IMSA TECHNICAL MEMO IWSC #21-05

Re: LMP3 Gearbox Vent and Lubricant Fill Quantity

Vent exit locations:

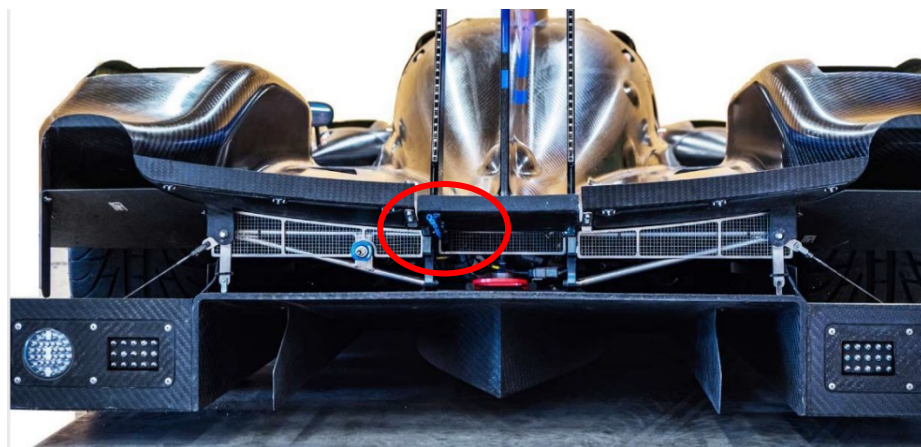
The required gearbox vent line routing is shown in the following photograph. The exit of the line should be flush with the homologated screen, not protruding more than 5.0 mm from the screen.
